Subject	Review of transport matters - Section 92 information requests	Project Name	New Lynn Primary School - 3094 Great North Road Designation
Attention	Katie Maxwell (Auckland Council)	Project No.	IZ131900
From	Jacobs New Zealand Limited (Jacobs)		
Date	10 August 2020		
Copies to	James Puketapu, Chris Horne, Achini Liyanagama, Terri Bell, Andrew Prosser

1.1 Purpose of this memorandum

Figure 2-1 Clark Street / Cambridge Lane and Clark Street / Great North Road intersections with right turn stacking space

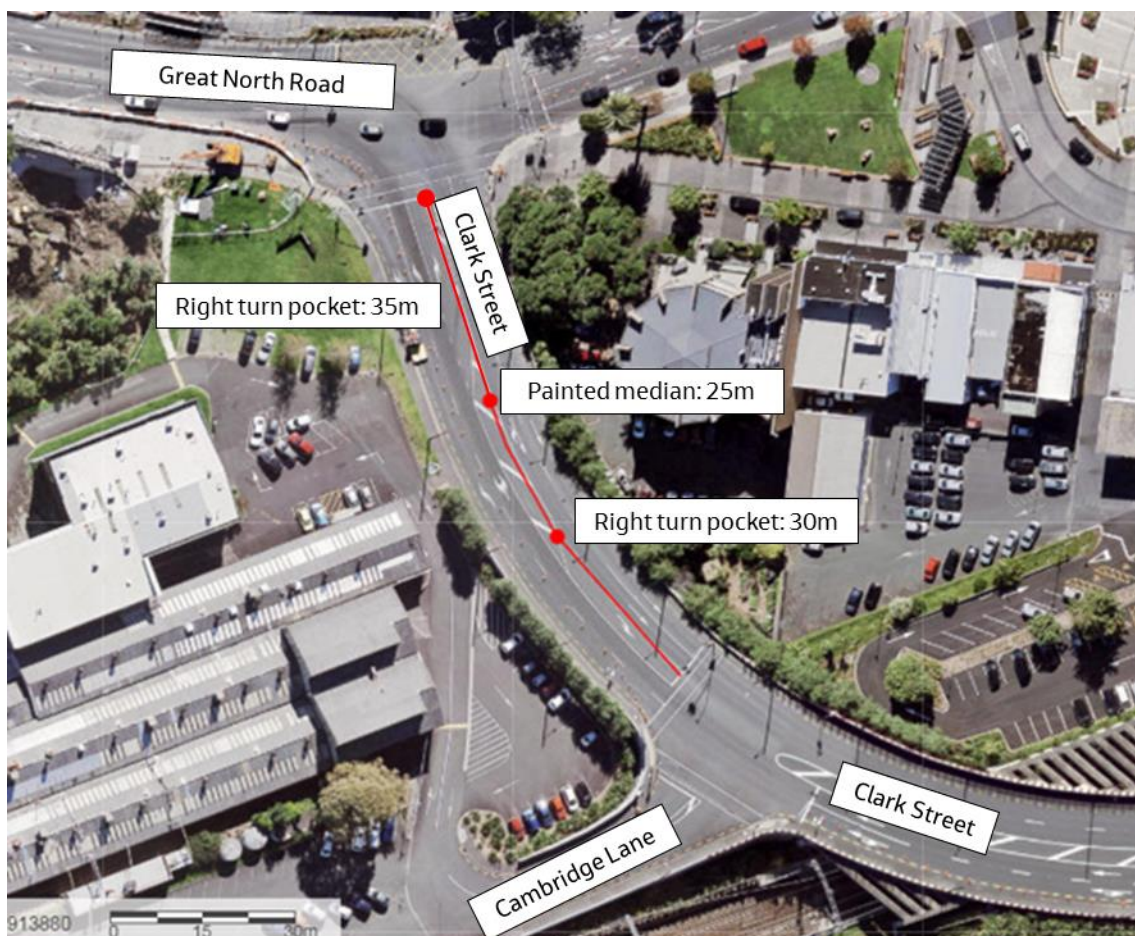
Please provide an assessment of the number of peak hour vehicle trips that can be generated by the site without vehicle queueing exceeding the stacking space of the right-turn lanes at the Clark Street/ Cambridge Lane and Clark Street/Great North Road intersections.

The right turn pocket (for vehicles turning right from Clark Street into Cambridge Lane) is approximately 30m long. If the length of the painted median is included, there is about 55m of stacking space for right turning vehicles.

If the 25m painted median on Clark Street is used to extend the queuing space for the right turn into the school, there would be a total of 55m of stacking space. If right turning vehicle queues are limited to 55m along Clark Street, it is not expected that queues will impact on Clark Street / Great North Road intersection operations (based on the modelling results for the Clark Street / Great North Road intersection which estimate queue lengths of four vehicles during the AM peak). However, right turn queue lengths greater than 55m would likely impact on the adjacent Clark Street / Great North Road intersection.

Using the model for Scenario 3, which includes optimised signals, the maximum number of vehicles turning right into the site during the AM peak without exceeding the 55m queue length would be 255 vehicles/hour, as shown in Table 2-7. This is a reduction of 61 vehicles/hour compared to the ITA modelled volumes. The SIDRA movement summary output for this test is shown in Table 2-8.

It is recommended that optimisation of the signals at the Clark Street/ Cambridge Lane intersection and extension of the right turn pocket (to approximately 55m using the existing painted flush median), is undertaken to support the development for the school. This proposed arrangement would accommodate right turn traffic volumes to 255 vehicles/hour which is a reduction of 61 vehicles/hour compared to the ITA modelled volumes. This is the maximum right turn pocket length that can be achieved that will maximise stacking space for queued vehicles but should not impact on Clark Street / Great North Road intersection operations.

Figure 3-1 Site visit observations and footpath widths for Clark Street north of Cambridge Lane

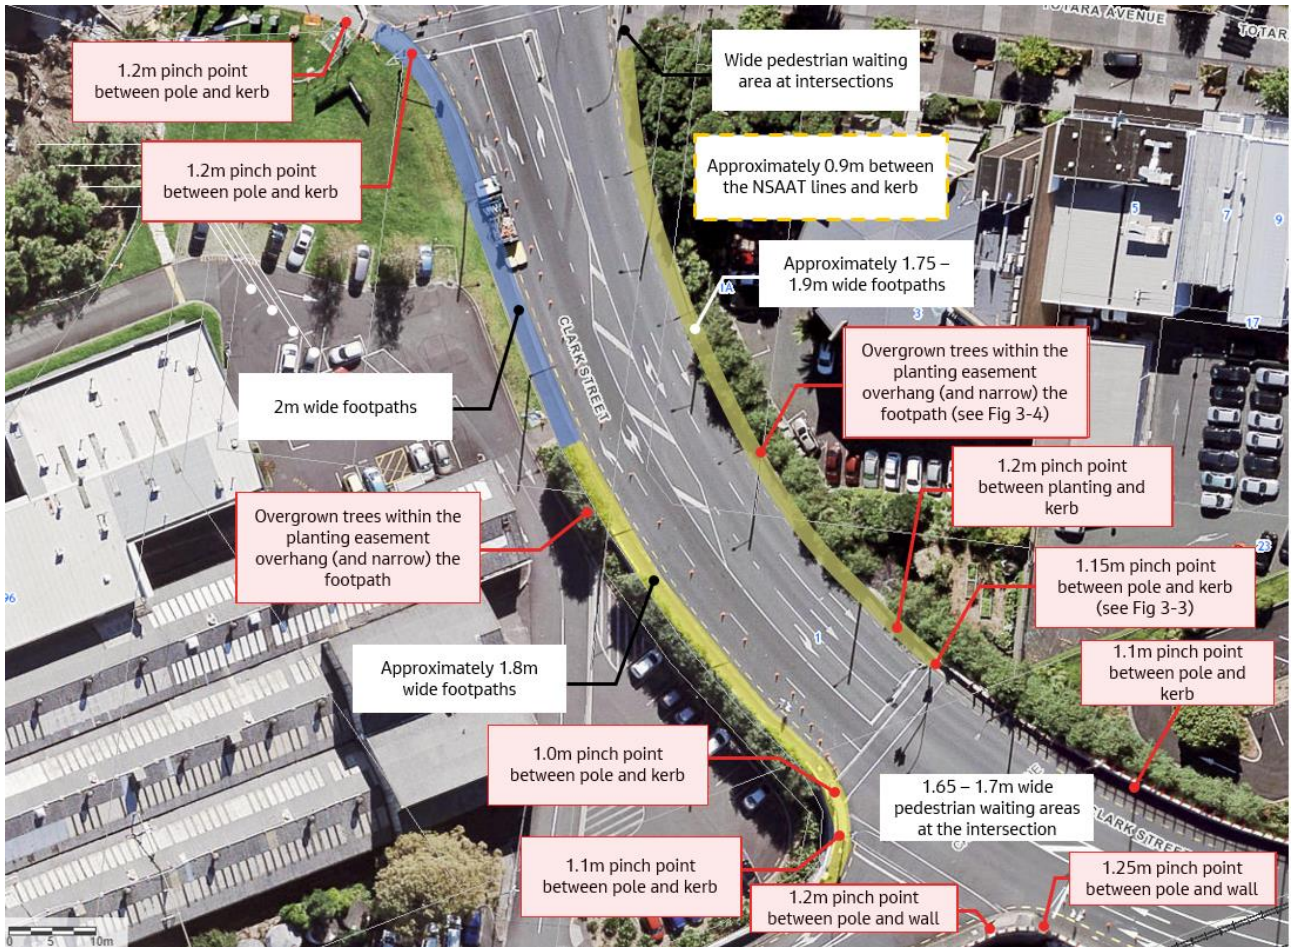
The site visit observations are summarised in Figure 3-1 and Figure 3-2. The main observations noted relating to the northern side of Clark Street include the following:

- Key area of concern is the footpath along the northern side of Clark Street;
- Footpath widths are generally narrow (under 2m) along the full length with several pinch points as noted (see Figure 3-3);
- No kerbs are provided along the section of the over-bridge structure from near the Cambridge Lane / Clark Street intersection to 60m east of the intersection. Kerbs provide a physical barrier and buffer for any vehicles which leave the carriageway;
- Footpath is along a continuous bend which means vehicles travelling south on Clark Street cannot see pedestrians on the footpath nor on the road ahead and the narrow footpath means a child could step out or fall into live traffic; and
- Bushes / planting on the adjacent property obstruct the footpath, further reducing the effective footpath width for pedestrians and people on scooters (see Figure 3-4).

Figure 3-2 Site visit observations and footpath widths for Clark Street south of Cambridge Lane

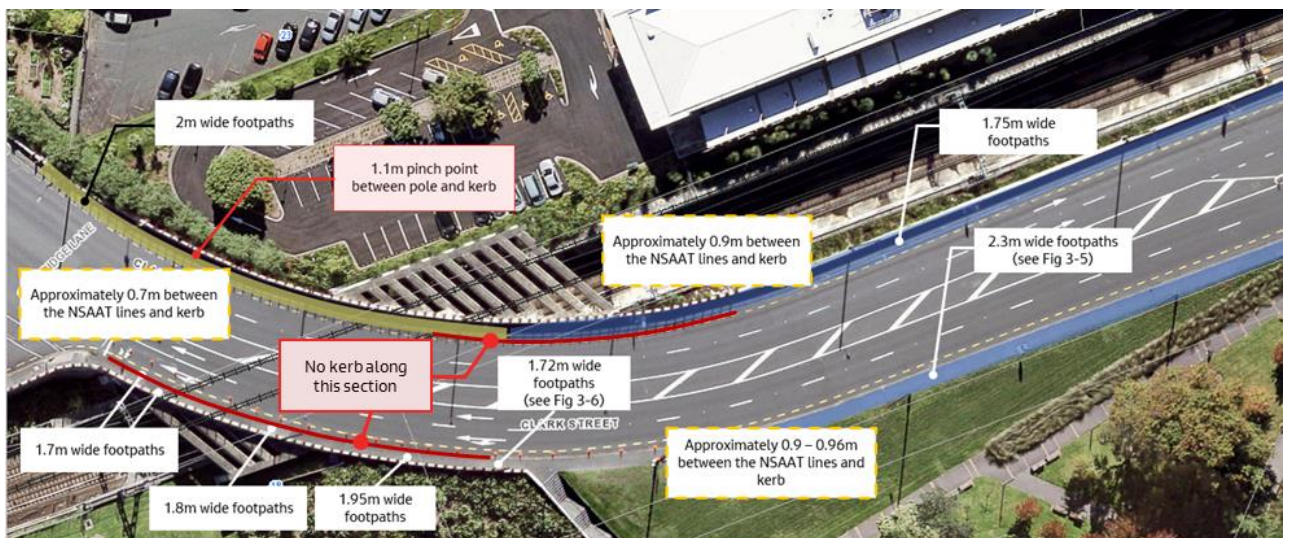
- Walking west along the southern side of Clark Street from Rankin Avenue, the footpath width is approximately 2.3m wide with a grass verge to the left until the steps which connect to Rankin Avenue (see Figure 3-5);

- From the steps to Cambridge Lane, the footpath is narrow (under 2m wide) and feels confined due to the solid concrete wall over the rail over-bridge (see Figure 3-6);

- No kerbs are provided along the section of the over-bridge structure from near the stairs to the Cambridge Lane / Clark Street intersection. Kerbs provide a physical barrier and buffer for any vehicles which leave the carriageway;

- There are several pinch points due to traffic poles at the intersection of Cambridge Lane / Clark Street; and
- Walking just north from Cambridge towards Great North Road, the footpath is still less than 2m wide and trees overhang the footpath further reducing the effective footpath width for pedestrians and people on scooters.

To address safety concerns and provide an adequate width for pedestrian movement, it is recommended that footpath widening is considered on the southern side of Clark Street to the south of Cambridge Lane, in particular the section between the school site and steps leading down to Rankin Avenue. This is to provide additional width for pedestrians walking on the footpath as well as increase pedestrian waiting space at the Clark Street / Cambridge Lane signalised crossing.

It is recommended that a total footpath width of at least 2.55m is provided along the southern side, subject to confirming any constraints of the overbridge structure. This allows for a 2.4m wide footpath through route and a 0.15m wide kerb zone which is in line with TDM minimum footpath width guidance (refer to section 3.3.1). The TDM notes that the footpath frontage zone can be reduced or

The current footpath is approximately 1.7m at its narrowest point which could be widened by a minimum of 0.7m into the existing 0.9m wide shoulder. It is recommended that a kerb is provided along the full length of the overbridge (subject to confirmation of any physical design or constraints or drainage requirements of the overbridge structure) and the existing kerb and channel would be shifted to provide for a 0.15m wide kerb zone. To maintain a 0.6m distance between the kerb edge and the edge line and the width of the edge line (0.1m), the two northbound traffic lanes would need to be shifted and realigned. It is estimated that the width of the existing 3.0m wide painted median would need to be reduced by a minimum of 0.55m to accommodate the widened footpath and realigned traffic lanes. These dimensions and are approximations only and are subject to further detailed design including vehicle tracking and confirmation of any design constraints relating to the overbridge structure.

Figure 3-8 Residential population distribution within the school catchment based on 2013 Census data¹⁰

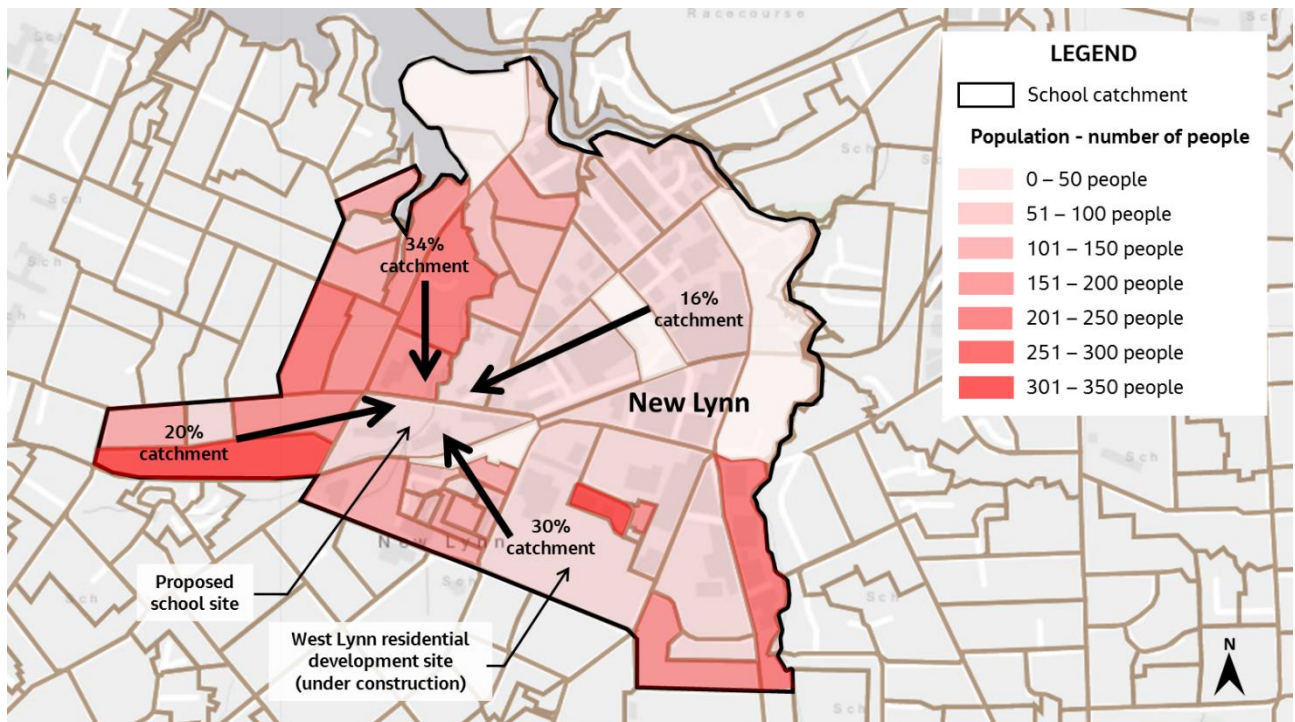
All students within the catchment zone for the school and ECE will live within approximately 1.5km of the site and as such, walking to school / ECE is likely to be feasible for a large proportion of students. Figure 3-8 shows the existing distribution of the residential population within the school catchment area.

Based on the population distribution it has been assumed that approximately 30% of students would be travelling to the school from the south and south-eastern areas of the catchment via Clark Street (including students walking, cycling and travelling by private vehicle).

Figure 4-1 Summary of recommended mitigations

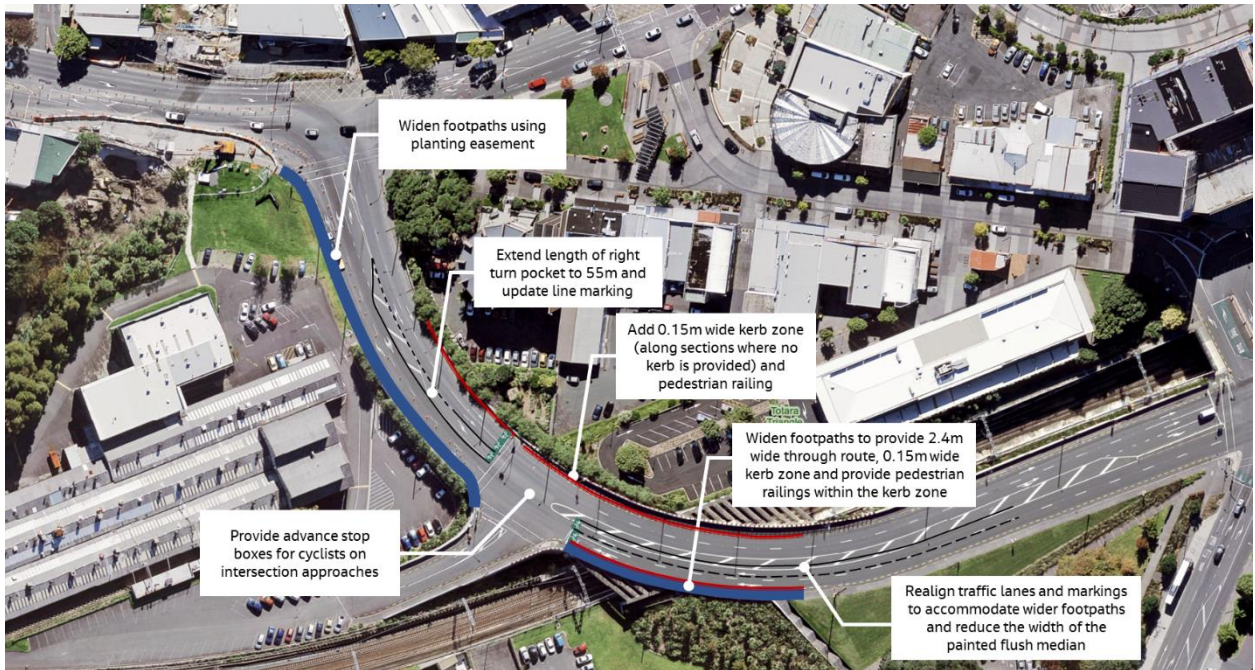
The mitigation measures recommended in this memorandum for consideration are summarised in Figure 4-1. In addition to the physical mitigation measures noted in Figure 4-1, the following safety, operational and travel demand mitigation measures are recommended:

- Future optimisation of signals at Clark Street / Cambridge Lane intersection, extension of the median right turn pocket on the northern approach to the intersection by 25m (to a total length of 55m), and required changes to line markings;

- Safety railings on the southern side of Clark Street between the intersection with the Cambridge Lane access and the stairs leading down to Rankin Avenue and northern side of Clark Street from 40m north of the intersection with Cambridge Lane to 90m east of the intersection. The exact location/ extent of the railings will need to be further investigated and confirmed at the later stages of the project in consultation with Auckland Transport;

- Cycling waiting facilities (i.e. advanced stop boxes) are considered at the intersection of Clark Street and Cambridge Lane to improve safety for staff members who wish to cycle to school;

- Footpath widening is considered on the south/west side of Clark Street south of Cambridge Lane, in particular between the school site and steps leading down to Rankin Avenue. In order to achieve this, reduction of the width of the existing median on Clark Street and realignment of the two northbound traffic lanes (south of Cambridge Lane) should be discussed with Auckland Transport; and

- Extension of the kerb along the full length of the footpath edge (subject to confirmation of any constraints along the overbridge structure).
